32.1157.111
November 14, 2022

Re: **Peer Review – Proposed McDonald’s Drive Thru Improvements
235 Spring Street, Winchendon, Massachusetts**

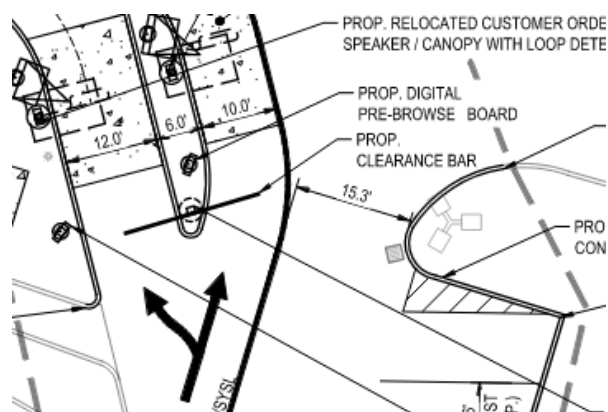
2. The Winchendon Fire Department has concerns regarding emergency vehicle accessibility, specifically at the 15'-3" driveway width as shown below:

We recommend the Applicant review fire apparatus maneuvering documentation to demonstrate that access around the building and proposed drive-thru ordering facilities can be achieved when the ordering queue is fully utilized. We recommend the Applicant confirm the proposed design meets the requirements of the Winchendon Fire Department.

Bohler Response: A fire truck turn exhibit has been included in the resubmittal package illustrating fire truck circulation around the rear of the building without conflicting with the proposed drive-thru equipment or encroachment into the drive-thru lane. It's further notable that once cars clear the drive-thru lane during a life safety event, the clear space for truck access between the curb and the drive-thru clearance bar is 19.6'. We have also reached out to Deputy Vaine with Winchendon Fire and are awaiting feedback on the proposed layout.

T&B Response: The provided Fire Truck Turn Exhibit presents graphical representation of the anticipate fire truck travel path, indicating that the apparatus can maneuver through the site. The comment has been addressed.
